PROJECT:  
**THE RIDGE AT LORSON RANCH**  
 FONTAINE BLVD. - WALLEYE DR  
 COLORADO SPRINGS, COLORADO

**THE RIDGE AT LORSON RANCH  
OVERLOT EARLY GRADING AND  
EROSION CONTROL PLAN**

Unresolved comment from Review #1:  
 Sediment traps are not sufficient for this application. According to MHFD Detail SC-8, they are for disturbed tributary areas <1ac. For >1ac, a sediment basin is more appropriate or add more more traps upstream. Calculate and show approx tributary area. The one to the right has >5ac trib to it.  
 And sediment traps should not block site access roads.

DATE: JULY, 2021  
PROJECT NO. 100.064  
SHEET NUMBER C4.8  
TOTAL SHEETS: 23

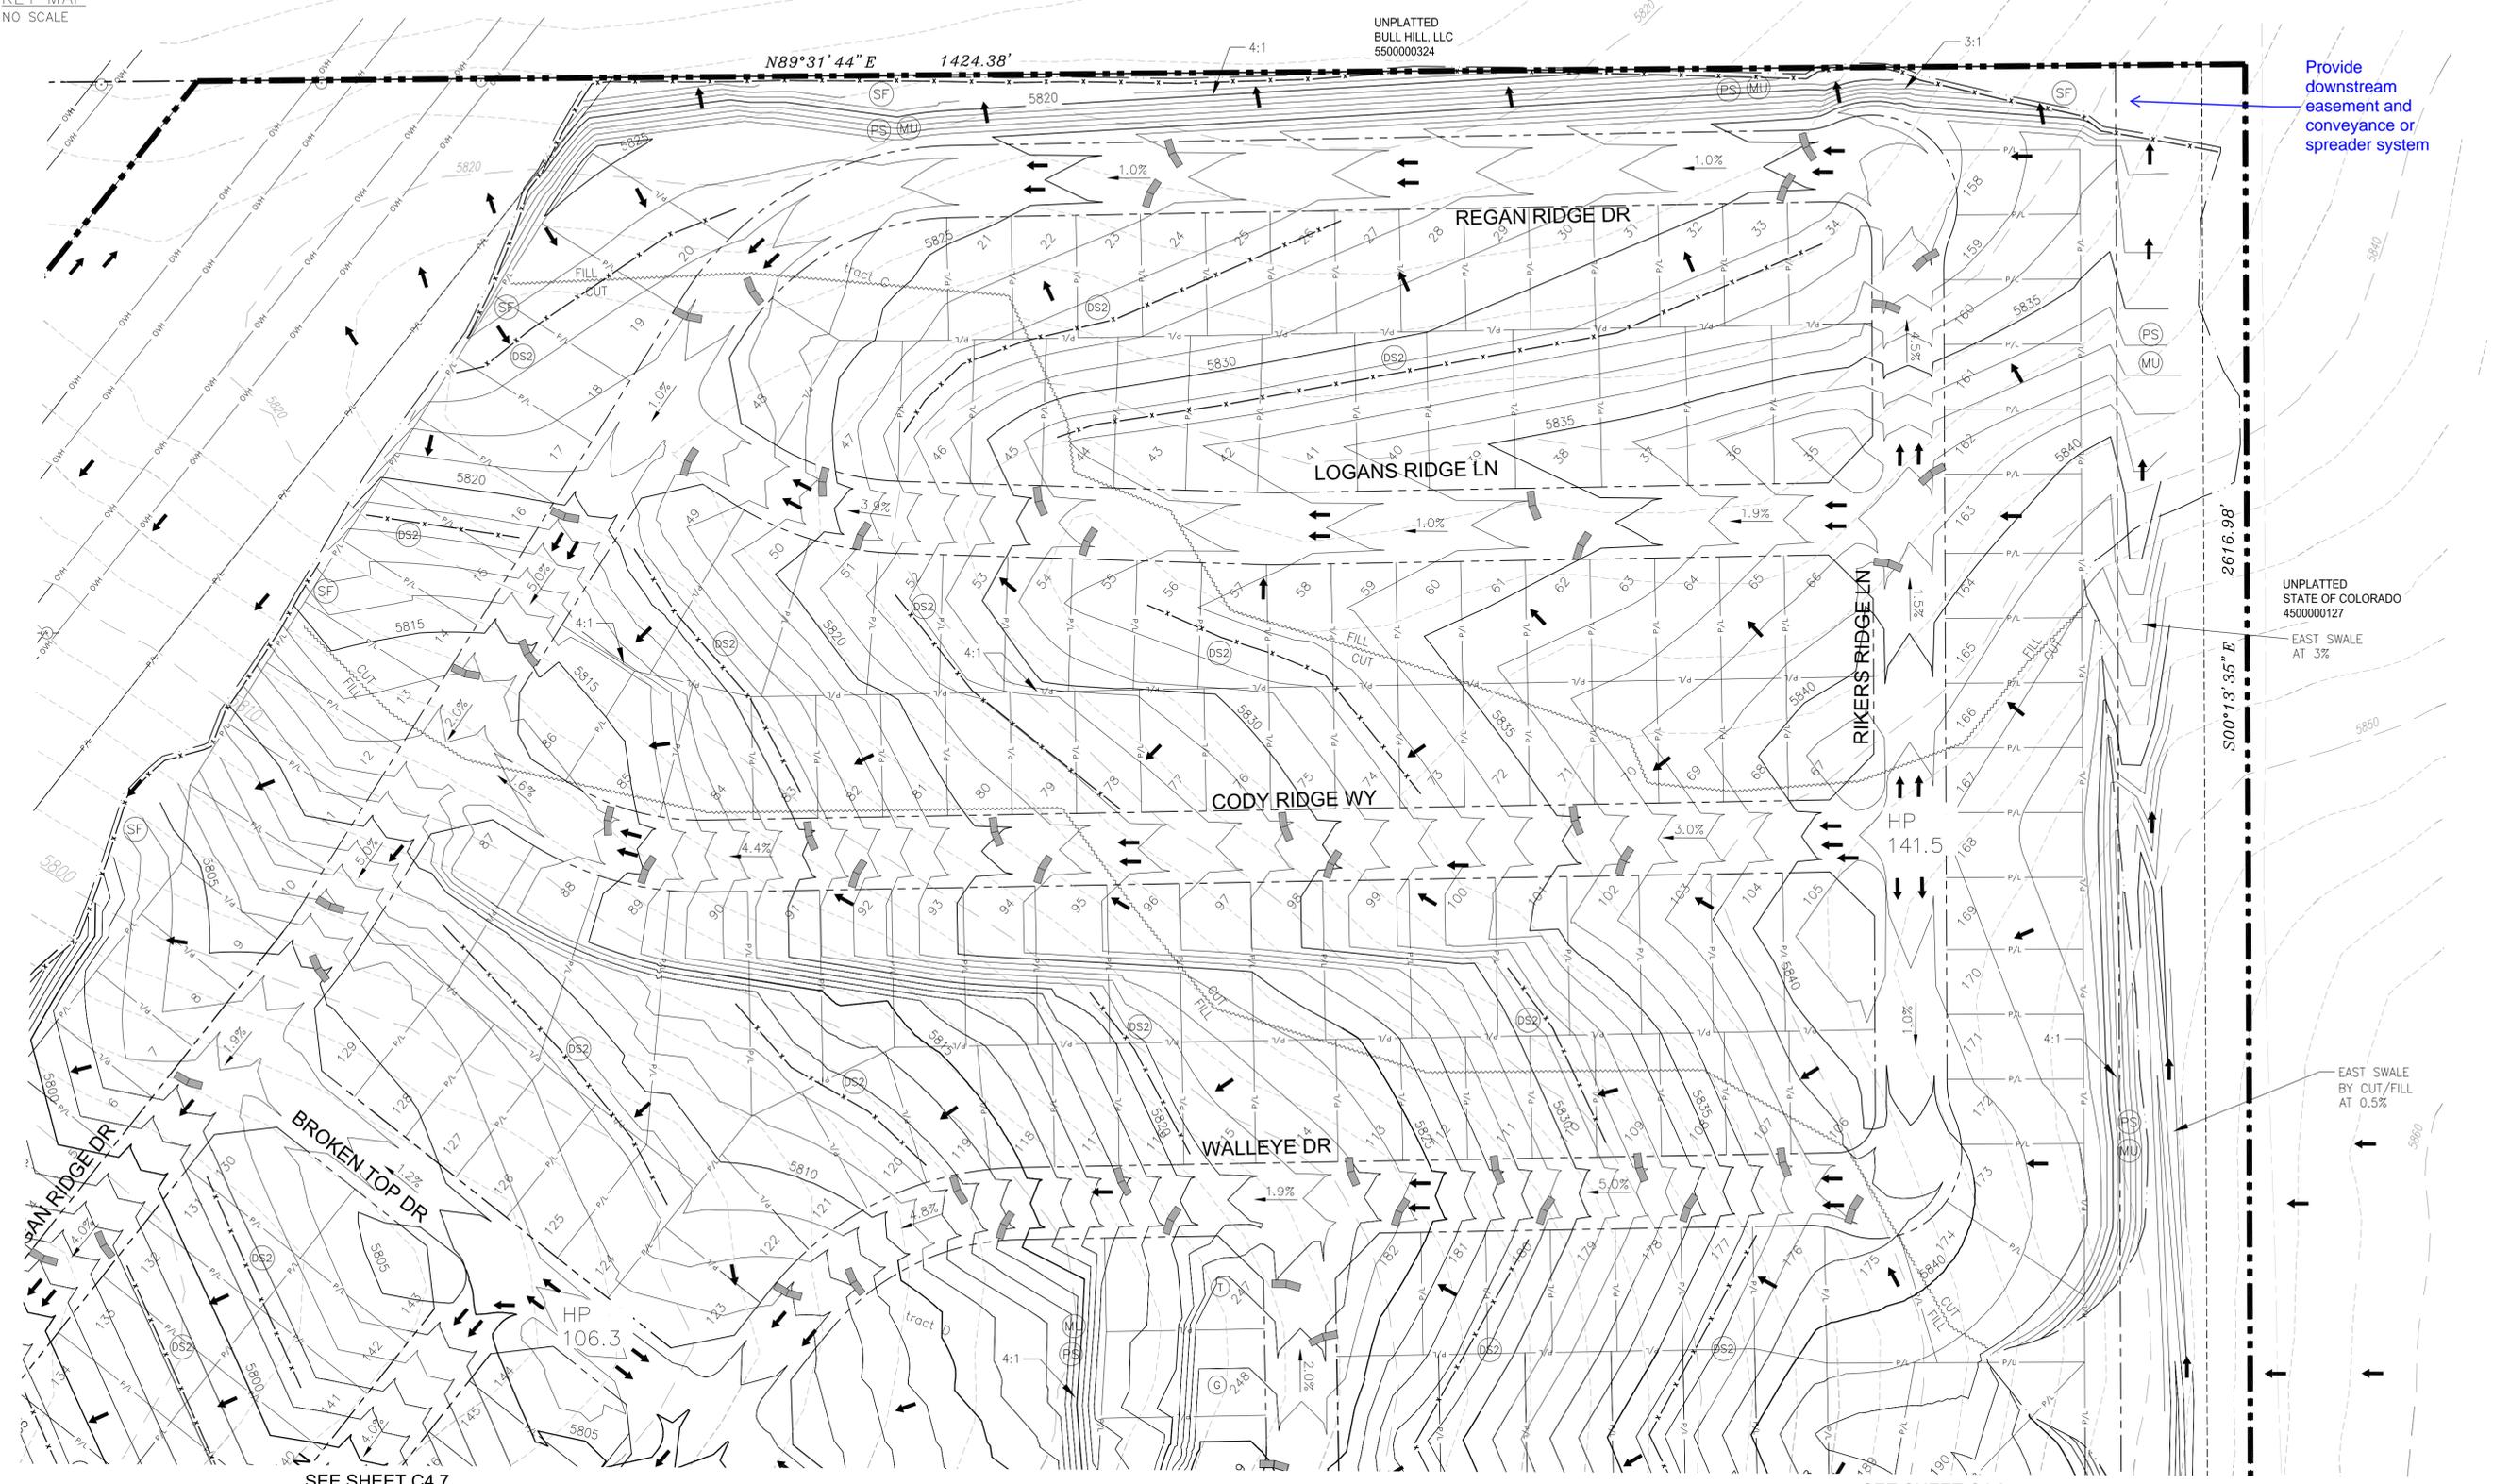
Provide downstream easement and conveyance or spreader system

<b>THE RIDGE AT LORSON RANCH TEMPORARY SEDIMENT BASIN C2.1</b>	
DATE:	JULY, 2021
PROJECT NO.	100.064
SHEET NUMBER	C4.10
TOTAL SHEETS:	23

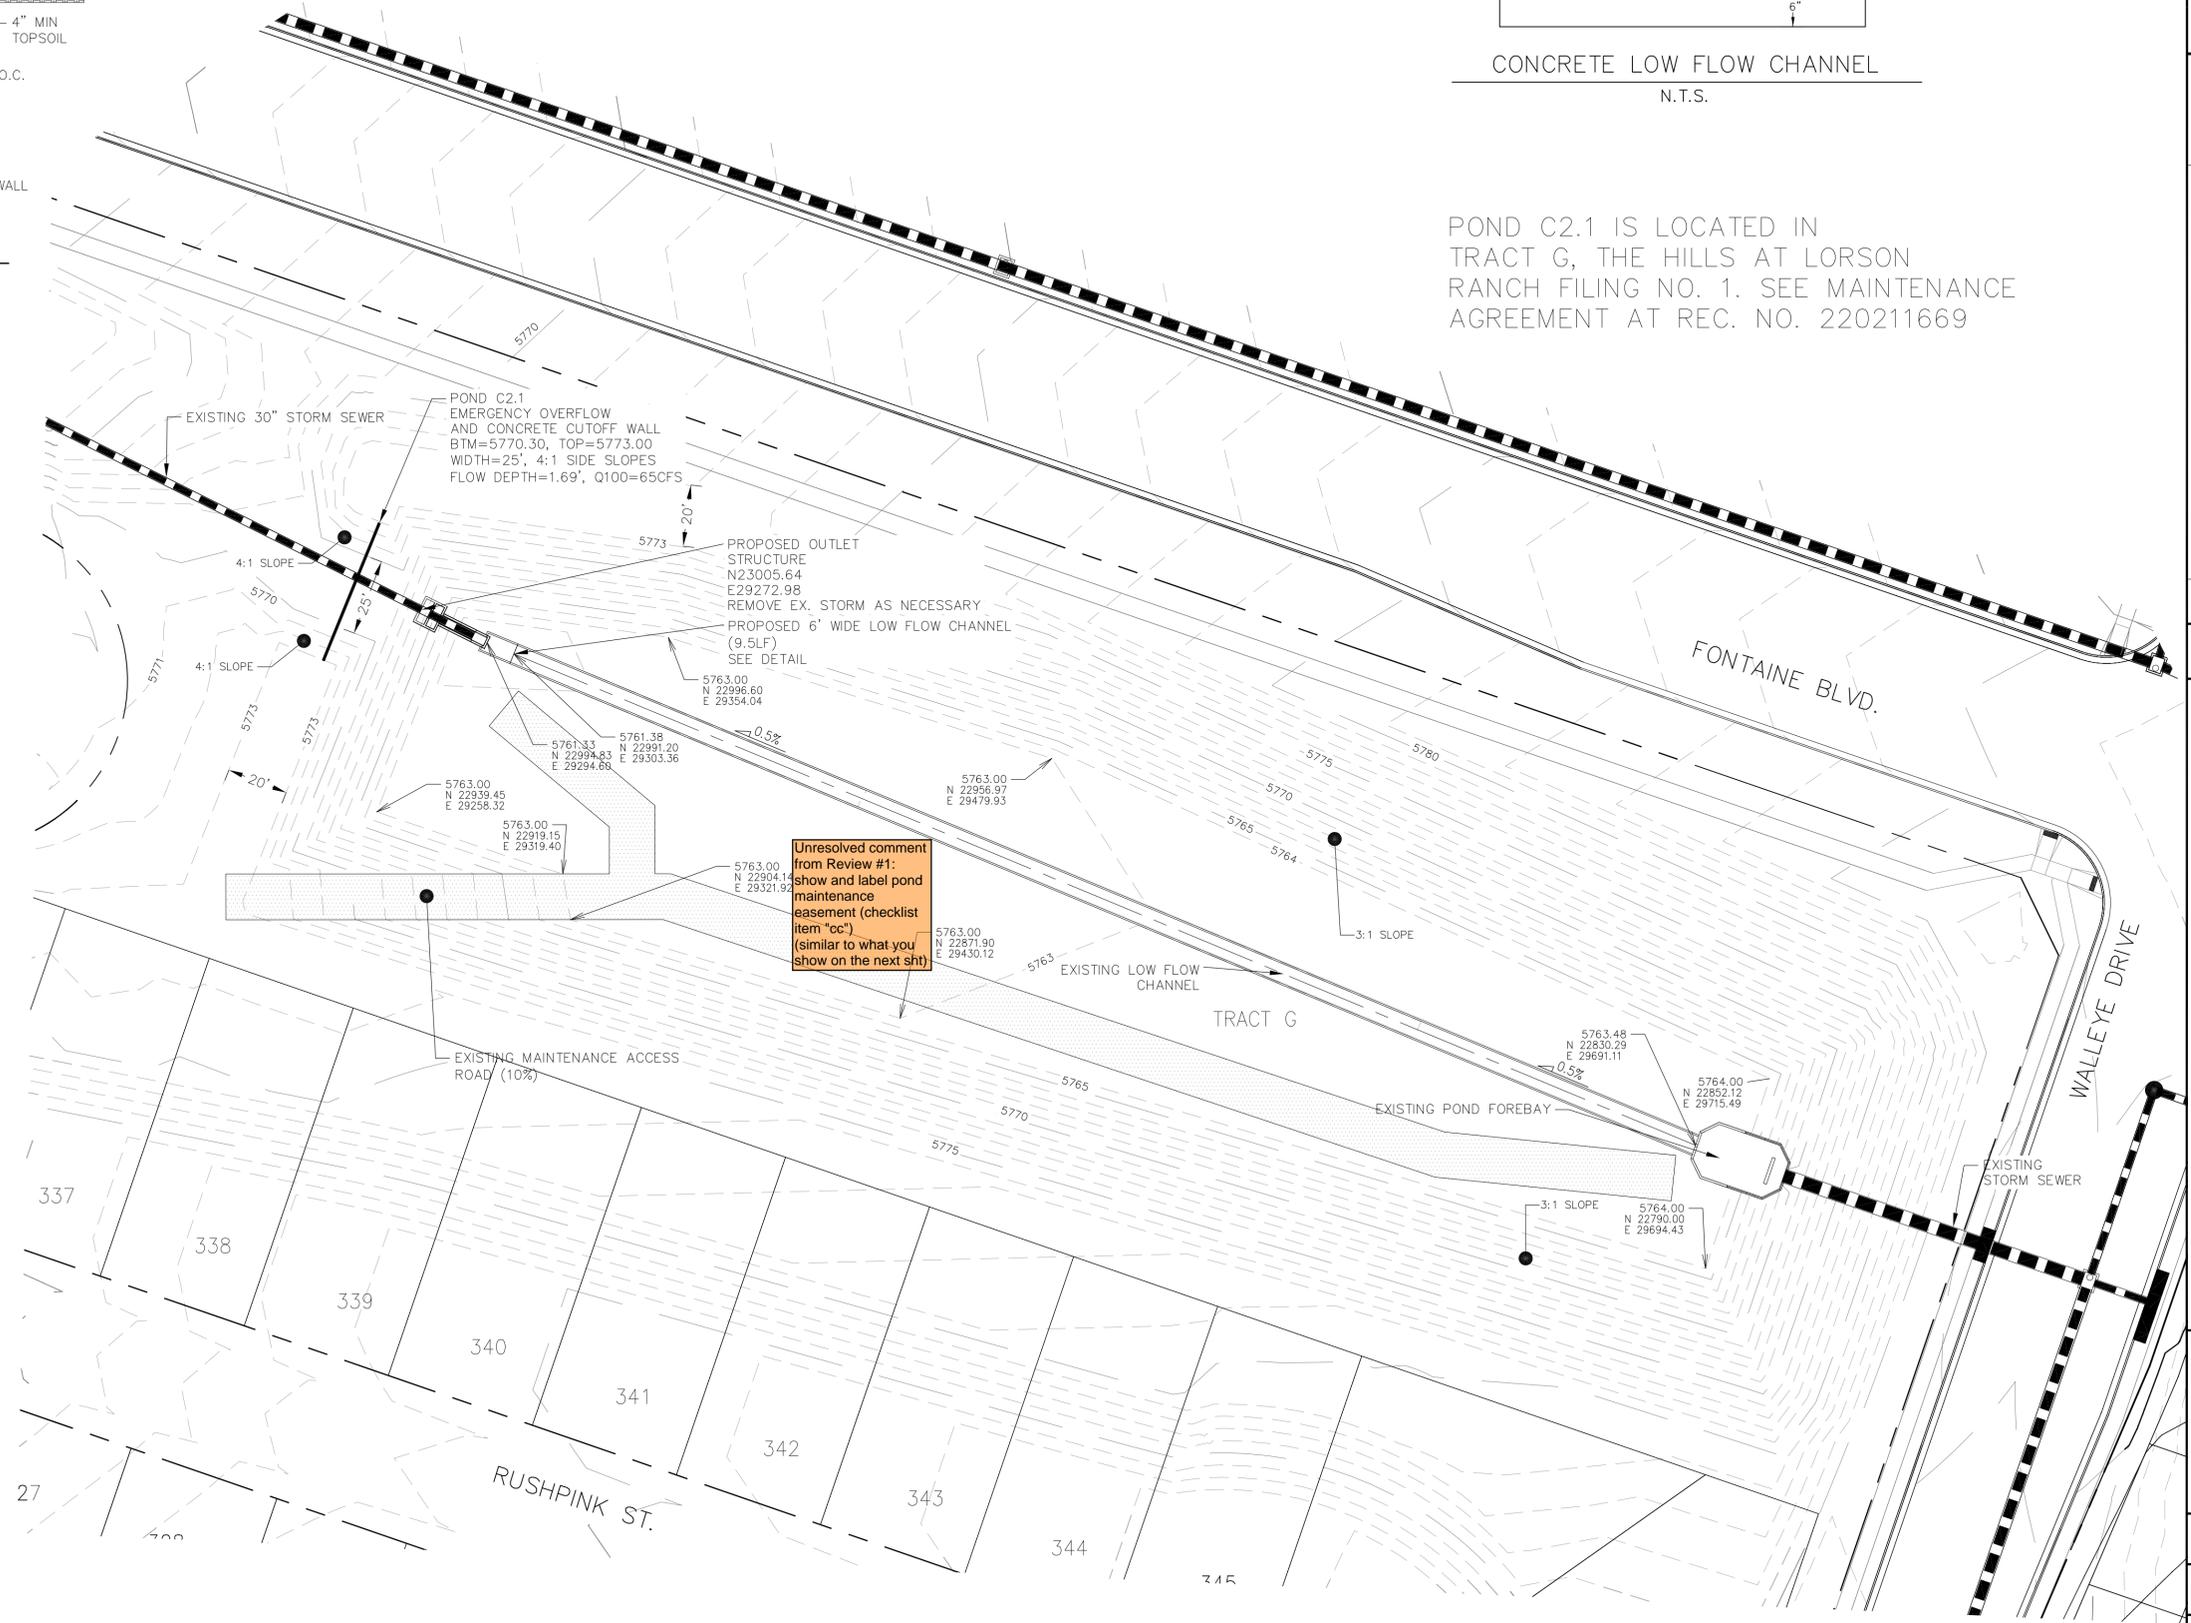
Unresolved comment from Review #1: show and label pond maintenance easement (checklist item "oc") (similar to what you show on the next sheet)

**POND C4  
 POND STRUCTURES  
 AND TRICKLE CHANNEL**

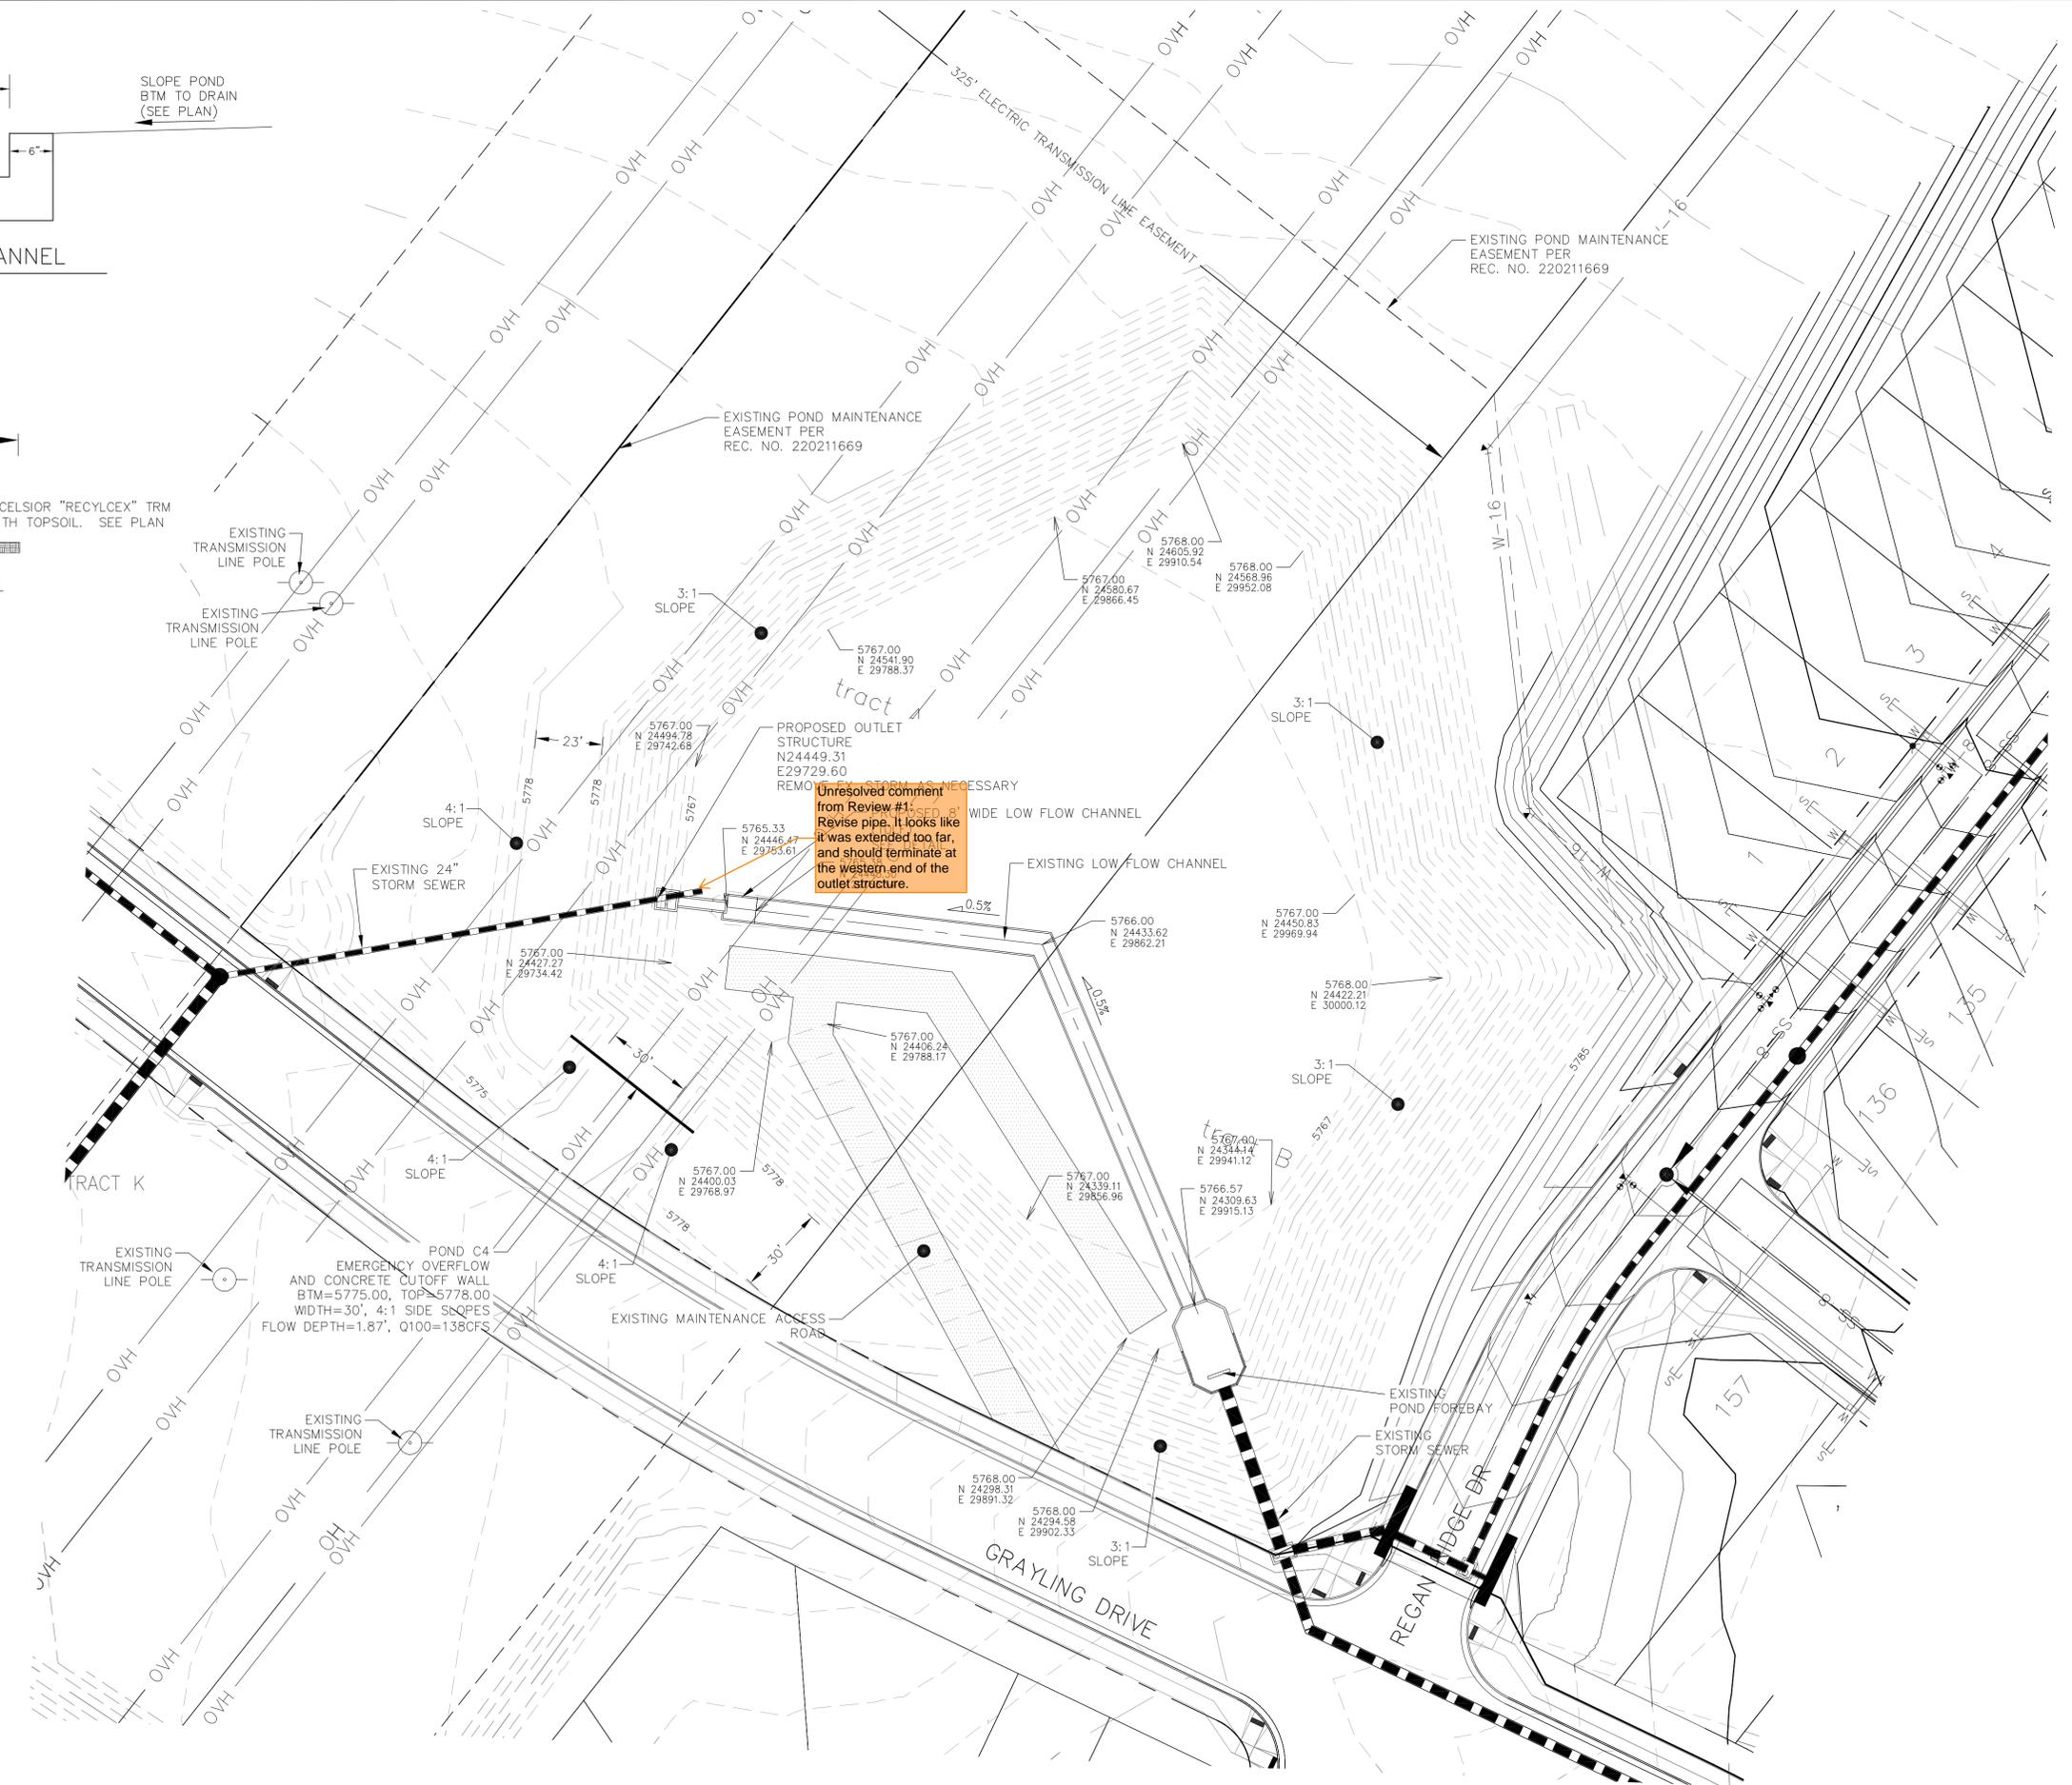
Unresolved comment from Review #1: **REVISE 8' pipe. It looks like it was extended too far, and should terminate at the outlet structure.**
